UNITED STATES PATENT AND TRADEMARK OFFICE

| APPLICATION NO. | FILING DATE | FIRST NAMED INVENTOR | ATTORNEY DOCKET NO. | CONFIRMATION NO. |
|---|-------------|----------------------|-----------------------------|------------------------|
| 10/567,750 | 02/10/2006 | Peter Lisec | 4301-1154 | 5637 |

Office Action Summary

DETAILED ACTION

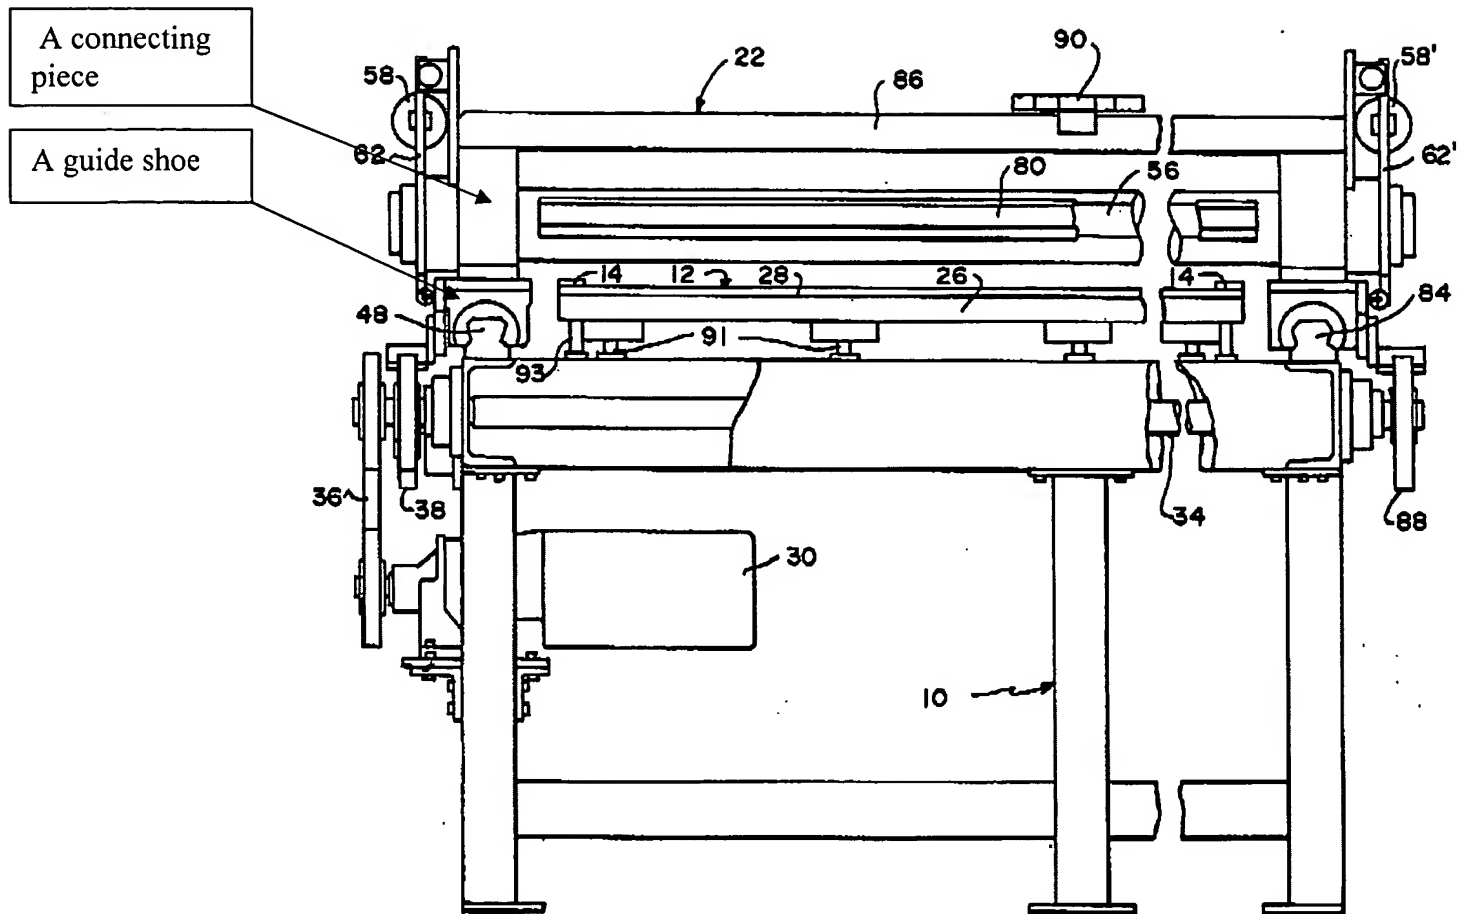
Regarding claim 15, Bergfelt teaches a glass cutting table with a top (12) which is used as a support for the glass plate to be divided, with a base frame (10), with a cutting bridge (22) which can be moved along the top (12), and with a cutting head (24) which can be moved on the cutting bridge (22), the cutting bridge (22) being guided on guides (48 and 84), and continuous conveyor elements (38 and 88) for moving the cutting bridge (22) along the top (12) being assigned to the ends of the cutting bridge (22), characterized in that the top (12) which is used as a support is mounted on the base frame (10), that the guides (48 and 84) and the continuous conveyor elements (38 and 88) are mounted on the base frame (10) independently of the top (12). See Figs. 1-3.

Bergfelt does not teach the guides (48 and 84) and the conveyor elements being located underneath the top (12).

Klages teaches guides (3) for guiding a cutting bridge 4 and the conveyor elements (6) being located underneath a top (2). See Fig. 1.

Therefore, it would have been obvious to one skilled in the art at the time the invention was made to provide the guides and the conveyor elements in the glass cutting

table of Bergfelt underneath the top as taught by Klages so that the width of the glass cutting table can be reduced while the supporting area of the top is unchanged for using the glass cutting table in a small warehouse.
